PARTS & SERVICE NEWS

REF NO.	AA04167
DATE	Nov. 03, 2004

SUBJECT: INTRODUCTION OF A HEAT-RESISTANT IMPROVEMENT O-RING

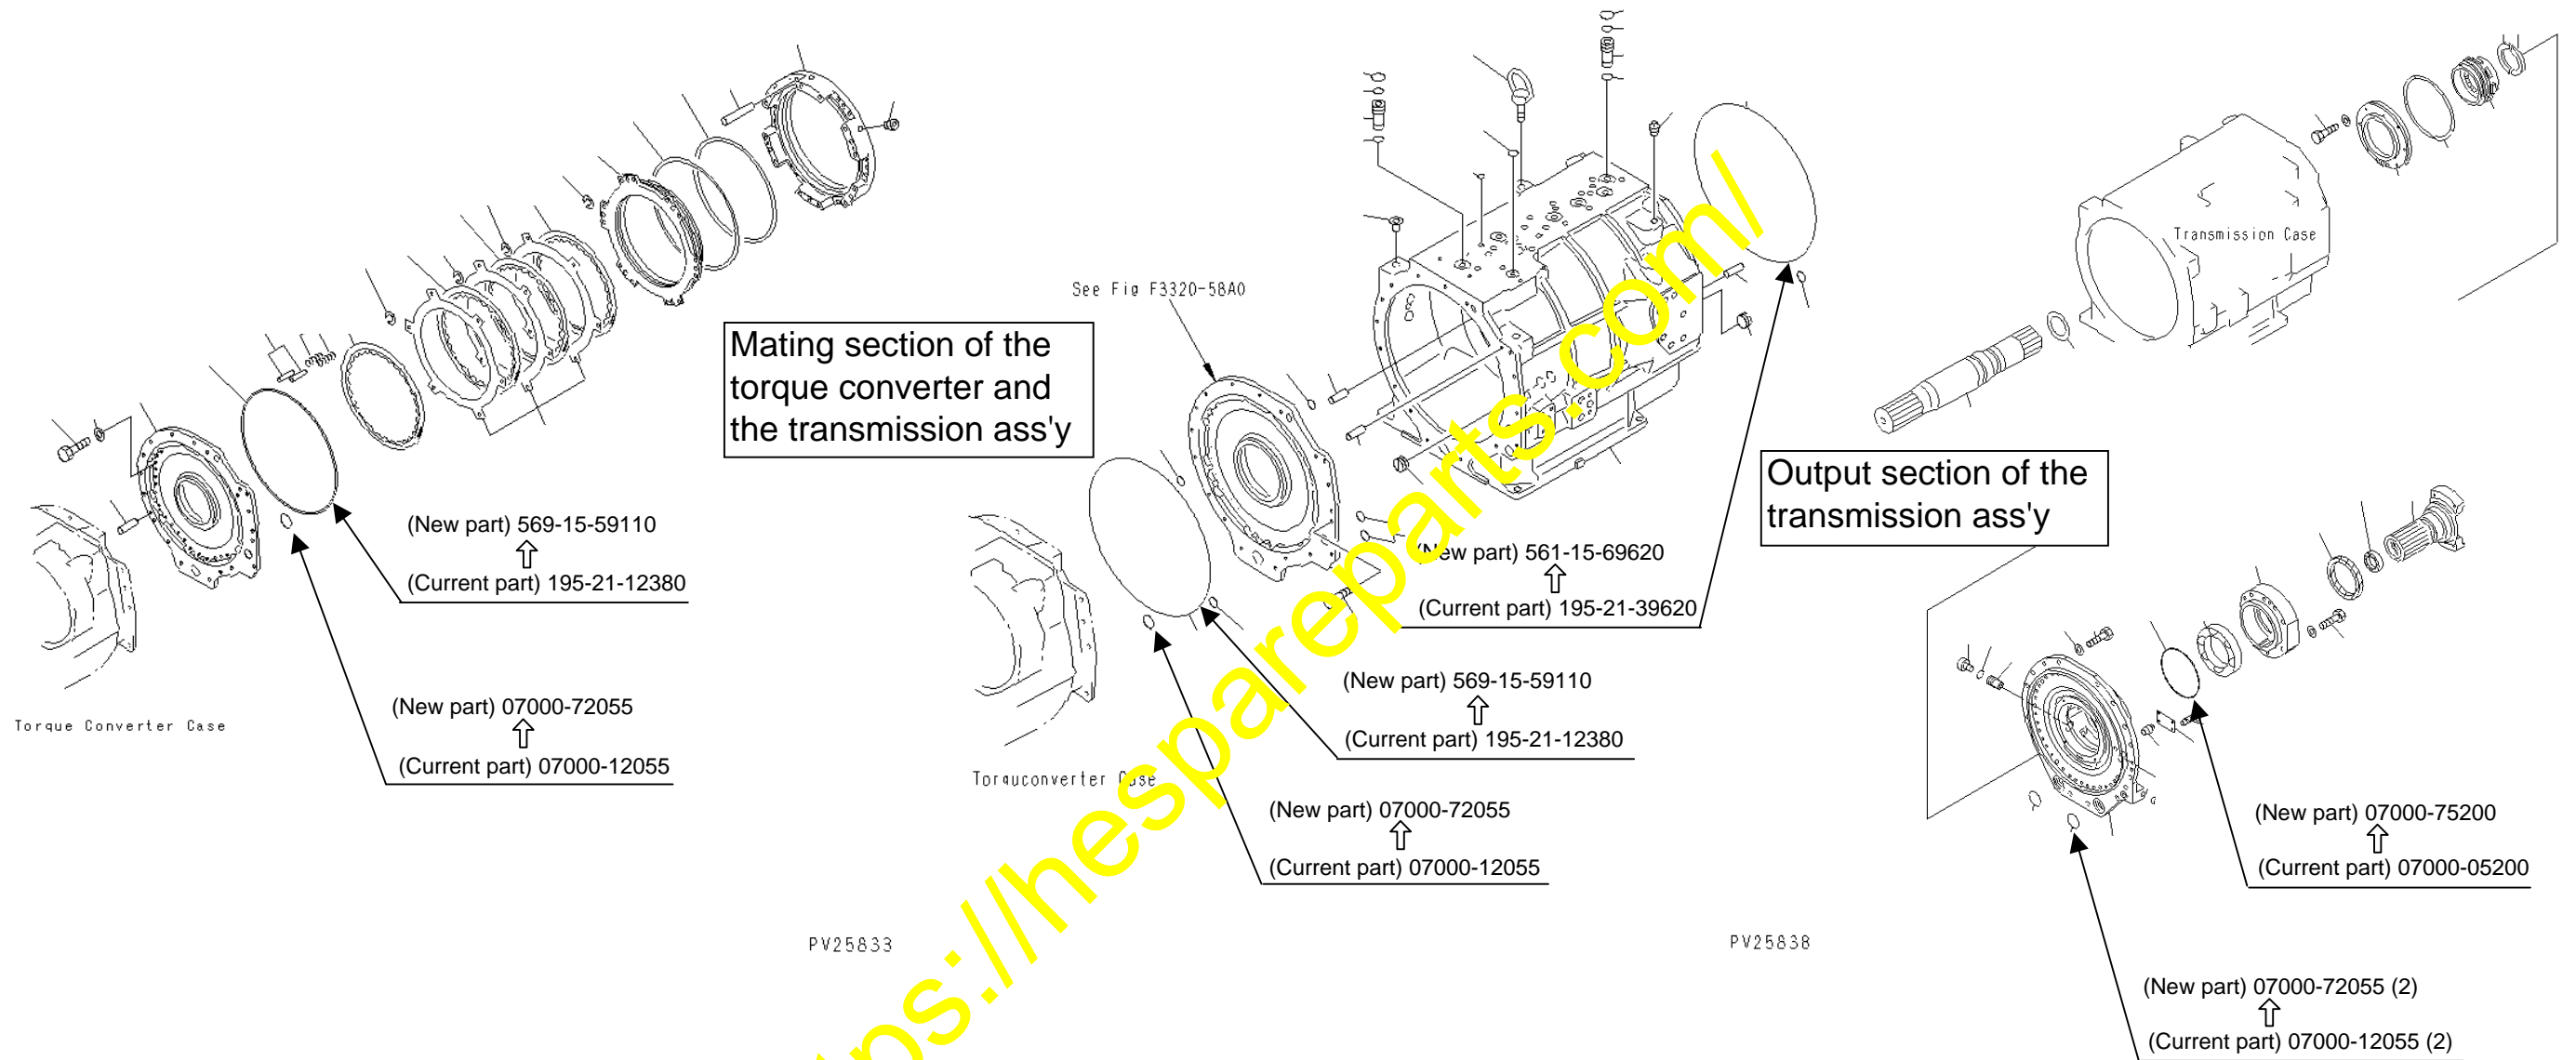
This Parts and Service News introduces a new heat-resistant O-ring used in the mating section of the torque converter and the transmission assembly.

The material of the O-rings being used for the mating section of the torque converter and the transmission ass'y and at the output section of the transmission ass'y have been changed from nitril to silicon, which is more heat resistant, to increase the heat resistance.

Part No.	Part Name	Q'ty	Remarks
07000-72055 (07000-12055)	O-ring	4	
569-15-59110 (195-21-12330)	O-ring	2	
561-15-69620 (195-15-39620)	O-ring	1	
07000-75200 (07000-05200)	O-ring	1
